AURORA HIGHLANDS CIVIC ASSOCIATION

Re: Melwood SPRC November 18 Meeting Concerns & Comments

Attachment B

Comparison between proposal and the Alternative Envelope Approved by AHCA

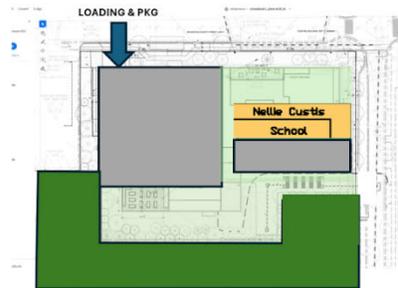
- Demo historic school
- Remove 10+ mature trees
- Loading dock by park, consume Grant St. parking
- Min. separation from park, not enough room for tree canopy with loading + transformer field
- 60 -70' + penthouse High-Med density
- 17% tree canopy excluding park
- Inadequate parking - overflow
- Unscreened raised party deck facing residential neighborhood & park
- Expands sidewalk into park in NE corner

- Adaptive reuse of the Nellie Custis School
- Retain mature trees per GLUP Study
- Parking entry and loading off of 23rd Street
- Heavy separation from park – allows for tree canopy
- 35' tall – actually Low- Med density
- 25%+ tree canopy excluding park – allows for open space, native / pollinator plantings
- Adequate parking on-site / below
- Solar roof potential

PART 1: RESIDENT SUGGESTIONS MARK-UPS SUMMARY CORE VALUES:

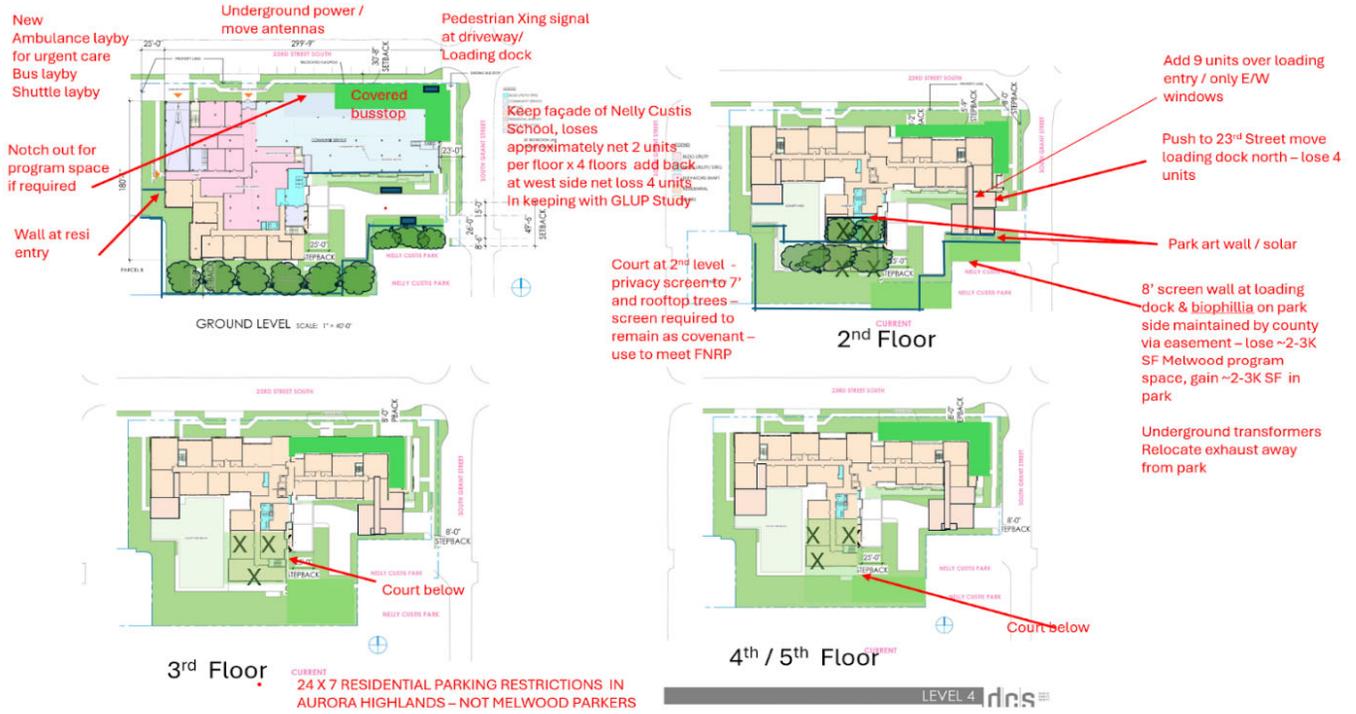
- MOVE BUILDING NORTH, USE SPACE OVER LOADING DOCK
- MINIMIZE FLOOR TO FLOOR HEIGHT, SET BACK AT TOP FLOOR, REMOVE TOP FLOOR
- USE SLOPE TO REDUCE HEIGHT
- USE LAYBY TO MINIMIZE CONGESTION ON 23RD STREET
- WALL AT PARK / BIOPHILLIC WALL
- REDUCE LIGHT POLLUTION ON RESIDENTIAL SIDE BY MOVING WINDOWS
- 24 X 7 RESIDENTIAL PARKING RESTRICTIONS IN AURORA HIGHLANDS – NOT MELWOOD PARKERS
- MAINTAIN BUILDING FAÇADE NELLY CUSTIS SCHOOL

1. **PARK / TREES:** Provides biophilic separation from park & meets FNRP
2. **PARK / ENVIRONMENT:** Reduces light pollution, addresses / improves park
3. **PEDESTRIAN & TRAFFIC:** Increases pedestrian safety & reduces congestion
4. **HISTORIC PRESERVATION / DENSITY:** Meets GLUP Study: historic facade, reduced SF
5. **PARKING:** Improves parking ratio & 24x7 parking restrictions mitigate overflow
6. **UNIT COUNT:** Approx 97 units + Melwood Program

PLAN VIEW

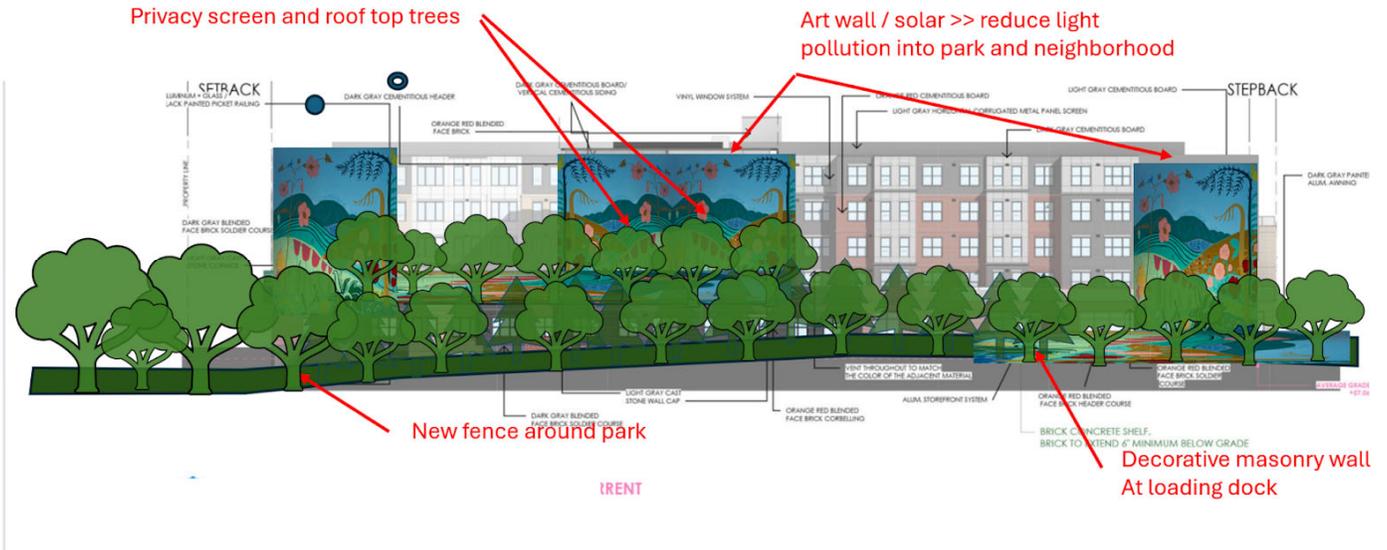
- Hold the building footprint (over one story) **north of the C-1/C-2 line** that runs along 23rd Street. Do this by **moving the loading dock north**, and removing the units that protrude south of this line. Add back the lost units over the loading dock entry and by pushing the building north toward 23rd Street including the setback.

- Include an **8 ft privacy screen at the 2nd Floor party deck** where it abuts the park and reserve an area outside the privacy screen for roof top trees or biophilia that will build the second story of a "biophilic wall".

- Include an **8 ft. sound dampening masonry wall** directly adjacent to the loading dock to separate the loading dock noise and fumes from the playground. Provide an easement for the land that is on the south and east of the loading dock and expand the playground area with heavy evergreen planting.

- **Relocate parking exhaust and the generator radiator exhaust to the west side of the building** away from the playground and pedestrians.
- Limit windows at the new units over the loading dock to east / west windows to allow the south wall to reduce light pollution into the residential neighborhood and act as a place for a **children's mural facing the park or solar panels**.

PART 2: HEIGHT STUDY, RESIDENT SUGGESTIONS FOR LOWERING HEIGHT

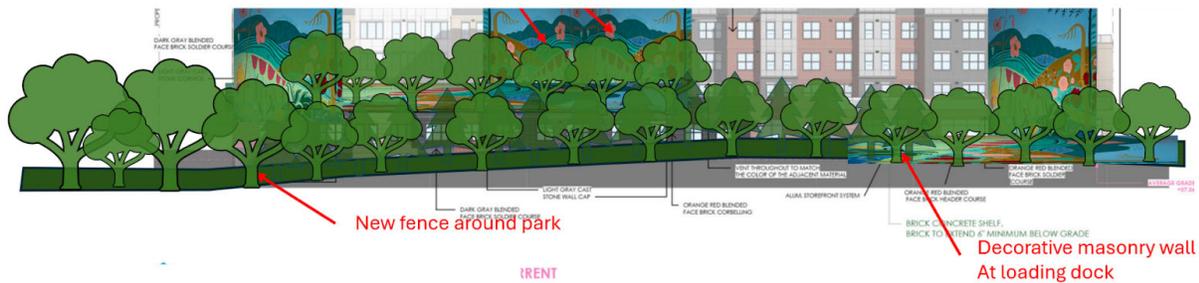
The PART 1 Study does not address the height. Residents are concerned that the height will create a negative precedent on 23rd Street and AHCA does not recommend any height over 35'. However, the following suggestions are to reduce the height as proposed to mitigate the most egregious impacts of height.

1. The developer should be pushed to reduce the maximum floor to floor heights as measured from an average of the site. 12' at the 1st Floor and 9.5 at the upper floors (assuming a DOAS system) and a 3' parapet = 53'

2. The developer should use the topography and slope from north to south to place the ground floor at ground level at the park side; it is currently nearly 1 story above grade in keeping with all guidance to transition to adjacent areas.

3. Reduced the number of stories.
 - a. Taking one story off reduces the height to 43.5' from 53', with a reduction of approximately 25 units bringing the total to 72 (large) units plus the Melwood Program, improves the parking ratio and minimizes the negative precedent.

SOUTH ELEVATION VIEW FROM PARK 43'

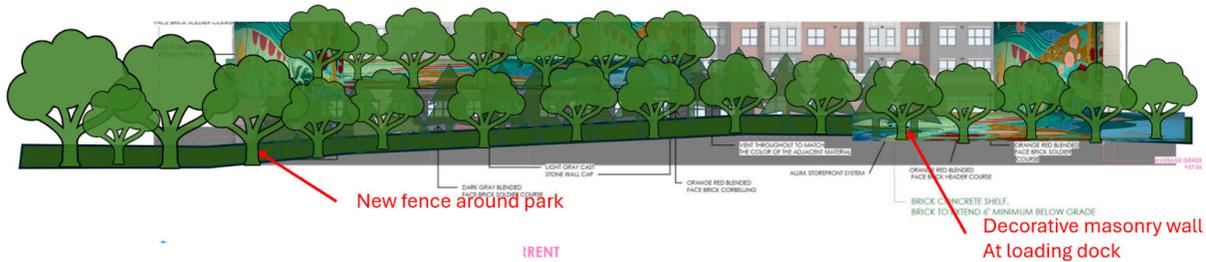
- b. Taking two stories off reduces the height to 35'- which is the appropriate height of the neighborhood, and yields 47 large units and, likely, adequate parking ratios.
